Evaluation of proposed new water right no. 50569

Proposed: Create a new water right no. 50569 and stack it onto the existing well authorized under water right no. 27099. Water right no. 50569 would provide an additional rate of 47 gpm. It will be limited to provide no additional quantity. Authorized rate at the well location will increase from 315 gpm to 362 gpm. Authorized quantity will remain at 240 AF.

Data Set: C:\Users\trevora\Documents\2021_Moves\50569\50569 Current.aqt

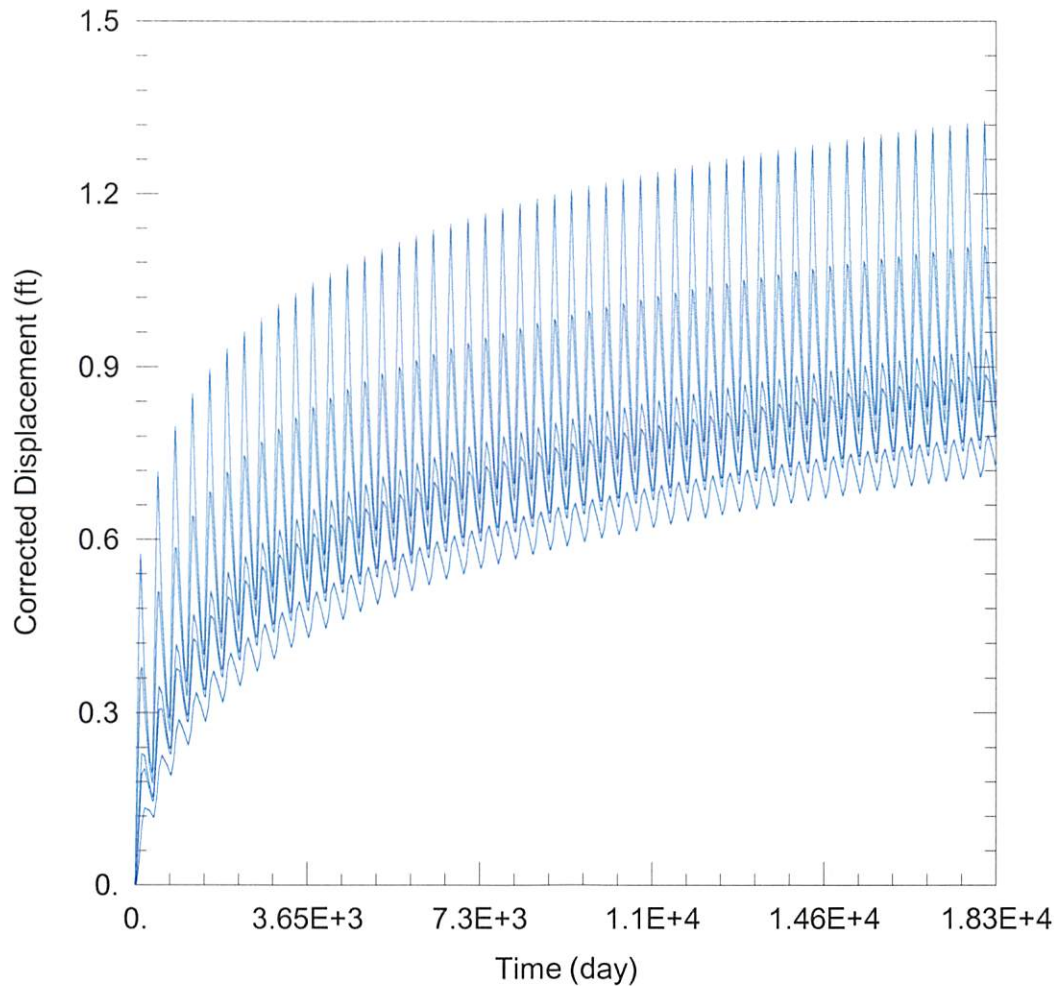
Net drawdown does not exceed the drawdown allowance of 1.0 ft for any well within 1 mile of the proposed location. Therefore, critical well analysis is not necessary.

The proposed new authority is located within an area with a depleted water table. However, analysis shows effects of running the well at an additional 30 gpm to be negligible. GMD3 staff recommends waiver of rules and approval of the application.
